QUEENSTOWN LAKES DISTRICT COUNCIL

Hearing of Submissions on Proposed District Plan

Report 11

Report and Recommendations of Independent Commissioners Regarding
Chapter 12, Chapter 13, Chapter 14, Chapter 15, Chapter 16 and Chapter 17

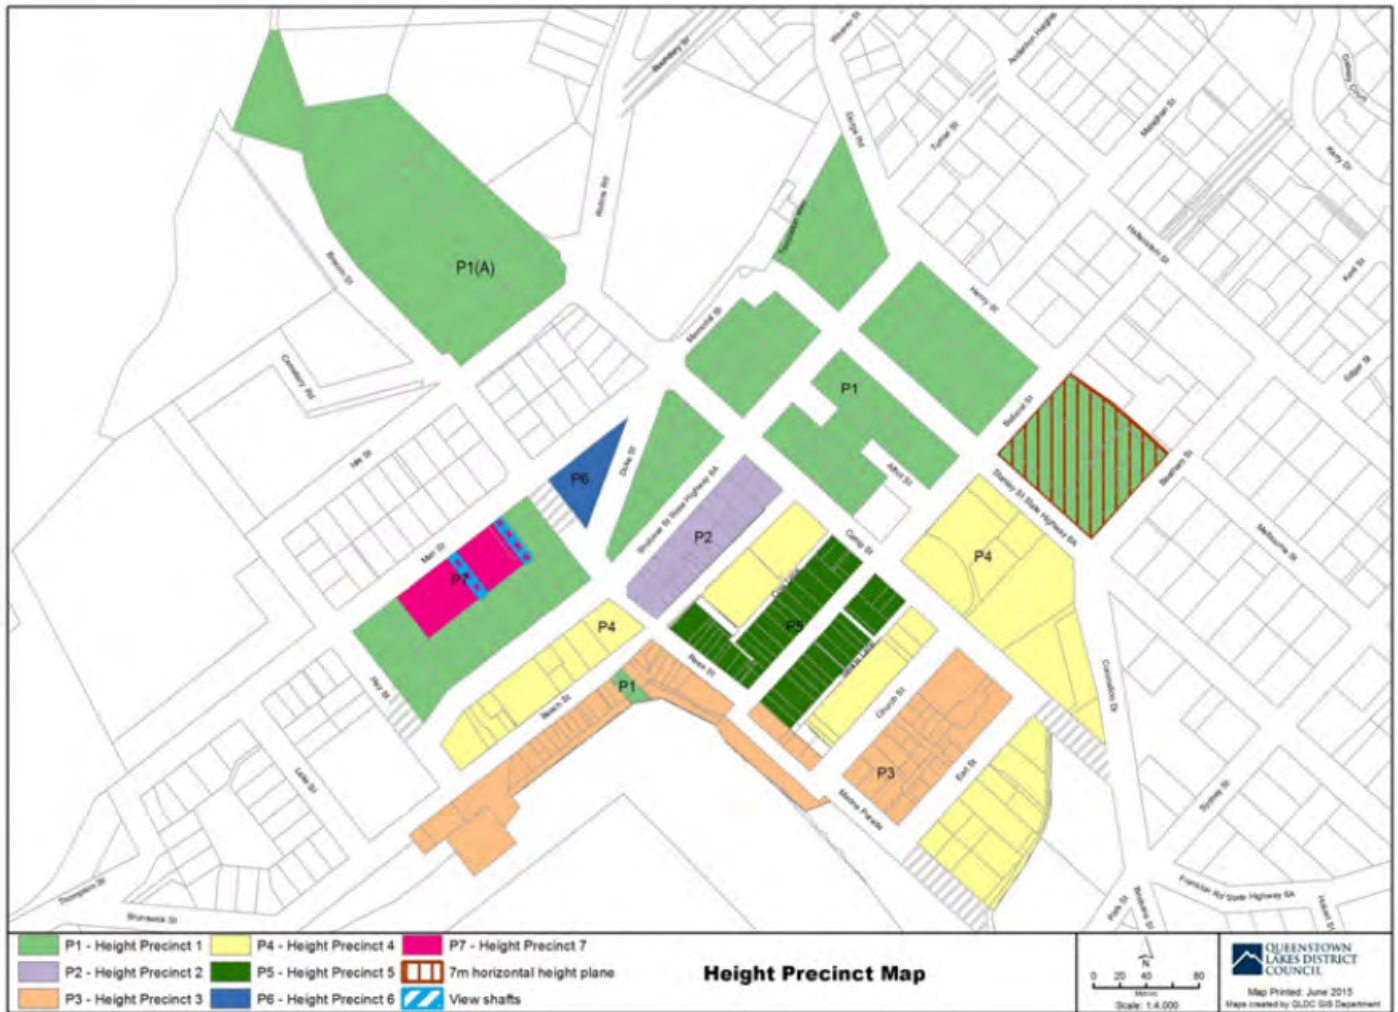
490. As notified, Rule 12.5.8 dealt with the provision of pedestrian links for any new buildings or building development in sites identified by the rule, both in Figure 1 and listed. Where the required link was not proposed, then the rule required consent as a restricted discretionary activity.

492. Peter Fleming³⁷⁰ sought that the pedestrian link map include legal descriptions on sites over which pedestrian links were provided. Tweed Developments Limited³⁷¹ considered that the notified Rule 12.5.8 and Figure 1 should also include pedestrian connections provided as a result of covenants and agreements between the Council and property owners.

494. Ms Gillies was very clear in her opinion that any existing pedestrian links should be retained.³⁷³ She was less certain on whether or not new links should be open to the sky or closed. She agreed Figure 1 (showing the existing pedestrian links) was inaccurate and should be updated.³⁷⁴ She supported new pedestrian links being encouraged as part of new developments. However, she did not think intended or proposed links should be shown on the PDP maps.³⁷⁵ She considered that new links should evolve from an assessment of the relevant site and after careful regard of design issues arising.

501. Following consideration of the submissions and the expert evidence of Ms Gillies and Mr Church, Ms Jones made a number of recommendations:³⁸⁷
- a. Correction of the notified pedestrian link map, Figure 1, so as to improve the map, accurately capture related legal descriptions, and ensure that all formal existing laneways in pedestrian links were included;

519. As to the submitters' concerns that including existing pedestrian links on Figure 1 within the PDP would amount to a *de facto* designation without providing them access to compensation, we find that we disagree.

533. The 8 November 2016 version of Figure 2 (S42A Figure 2) was as follows:

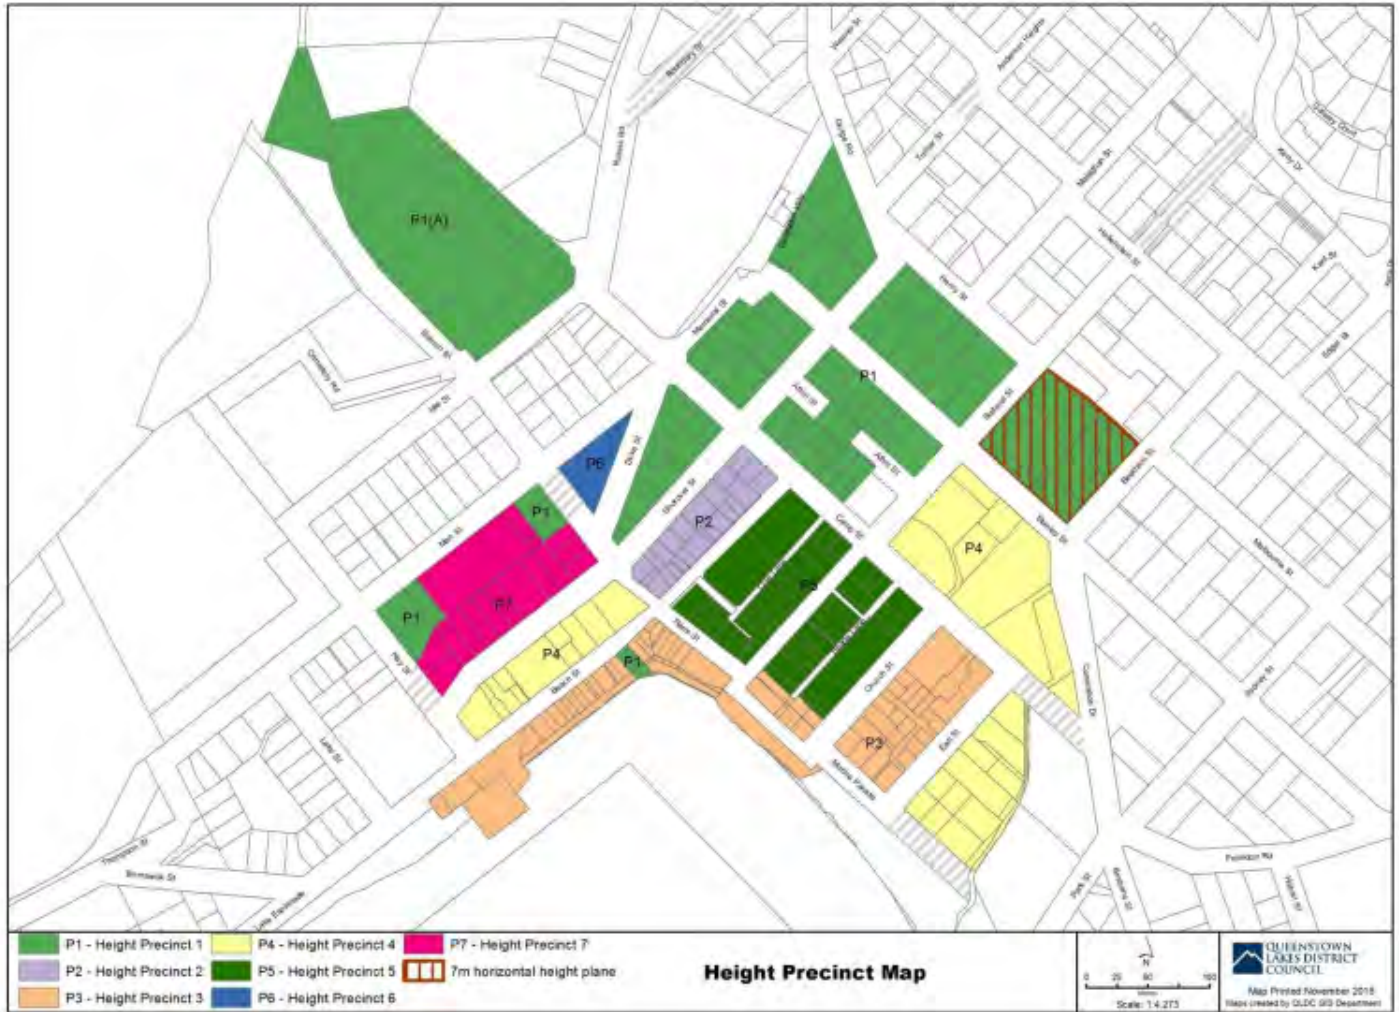
529. Rules 12.5.9 and 12.5.10 both referred to the Height Precinct Map, Figure 2, which identified the height precincts and their locations. We will refer to this throughout our report as Figure 2, and identify which version we refer to. In addition to this, we include Figure 2 in the following discussion in order to aid the reader in understanding how the height precincts and rules evolved through the hearing process.

530. Christine Byrch⁴²¹ neither supported nor opposed notified Figure 2 and therefore we recommend this submission be rejected.
531. Notified Figure 2 was included in Chapter 12 as follows:

532. While out of chronological order, we note here the version of Figure 2 attached to Ms Jones Section 42A Report was inserted by error. Prior to the hearing, by memorandum of 8 November 2016, a version of Figure 2 consistent with the recommendations in her Section 42A Report, was circulated to all participants. That Map contained the following amendments to the Precincts:
- Precinct 7 was extended down to Shotover Street to include the majority of the Man/Hay/Shotover/Brecon Street Block
 - Precinct 5 was extended to include those parts of the south side of Upper Beach Street and the North side of Church Street, which were shown as Precinct 4 in the notified version
 - That part of Precinct 3 between the Mall and Church Street was extended north-east to include the adjacent sites.

Reply Figure 2

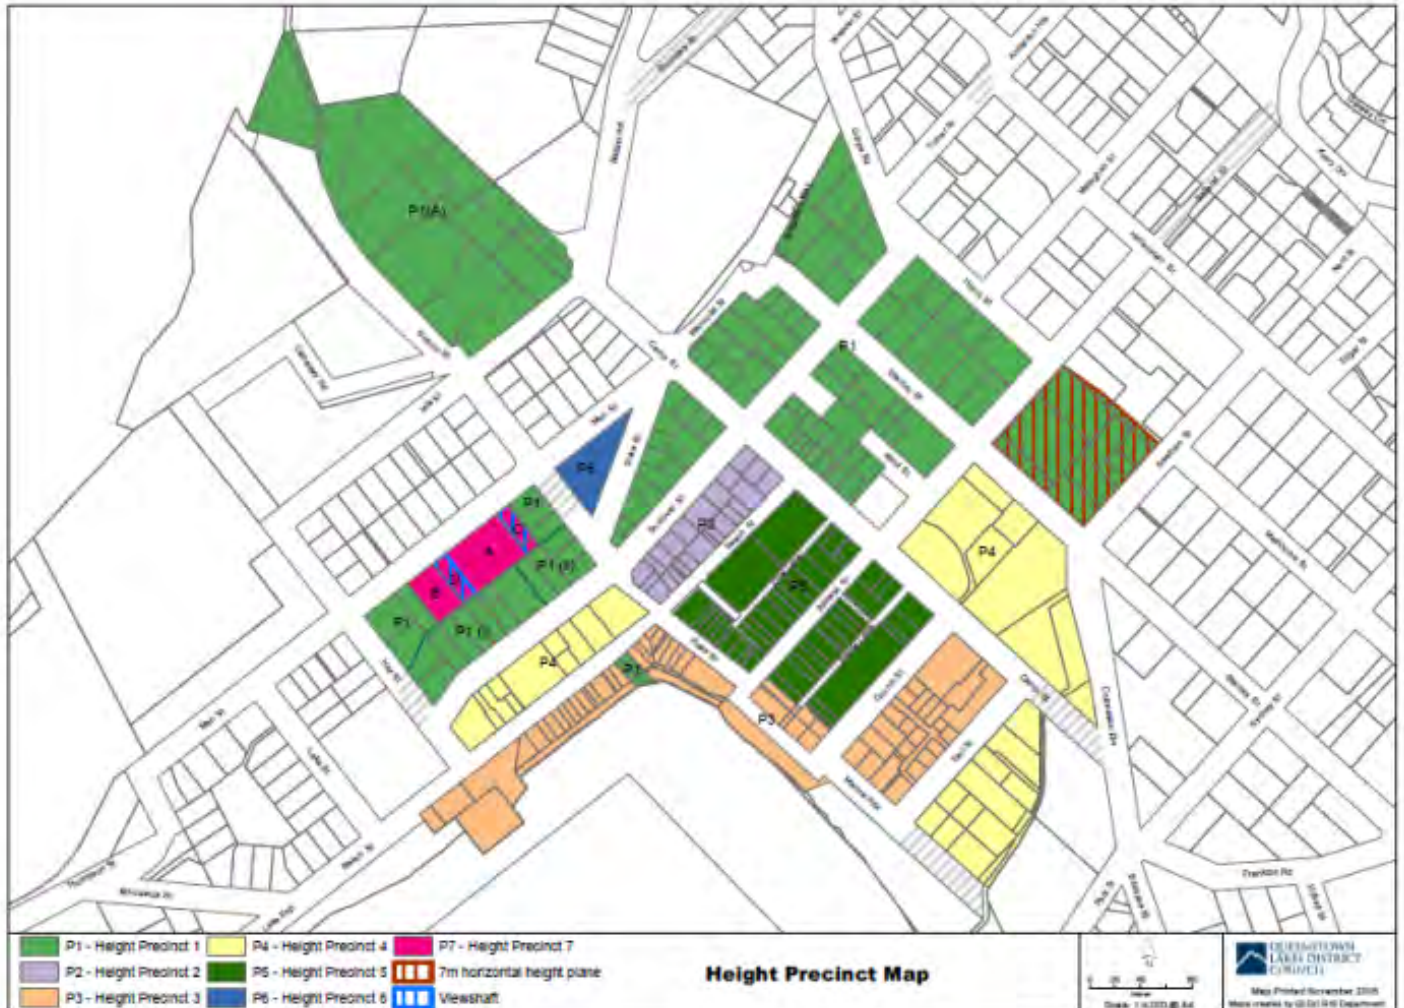
681. In her Reply⁵⁶¹, Ms Jones responded to Mr Farrell's evidence and questions, by recommending that Areas E and F (as shown in notified Figure 2) be removed from Precinct 7 and replaced with Precinct 1, and consequential changes be made to Rules 12.5.10.4 and 12.5.10.1. These consequential changes included adding a rule to 12.5.10.1 that no building exceed a horizontal plane at 271.1/ 330.1 masl. The recommended rules in Appendix 1 to her Reply Statement would have the effect of providing the restricted discretionary activity status to buildings between 12 and 14m above ground level as in the rest of Precinct 1, while ensuring that anything above either 14m above ground level or 271/ 330 masl respectively would be non-complying. She considered this to be more efficient and effective than redraft Rules 12.5.10.4(e) and 12.5.10.4(f) that applied to this area in the version attached to the Section 42A Report.

684. Included in Ms Jones' Reply Statement was her final recommended Figure 2 (Reply Figure 2). We include this below in order to aid in understanding the recommendations that follow. Reply Figure 2 is also included in our recommended Chapter 12 set out in Appendix 1.

685. Having carefully considered the evidence of Mr Farrell, the opinions of Mr Church, and in particular Mr Church's amended Figure 20⁵⁶⁶, and the reasons advanced by Ms Jones, particularly within her Reply evidence to support her amendments to the rules relating to areas E and F, we agree with her reasoning and accept the opinions of Mr Church.

701. We agree with the evidence of Mr Williams and Ms Jones on this point and accept Ms Jones' reasoning for the change in the location of the western view shaft. We recommend adoption of this change as shown on Reply Figure 2.
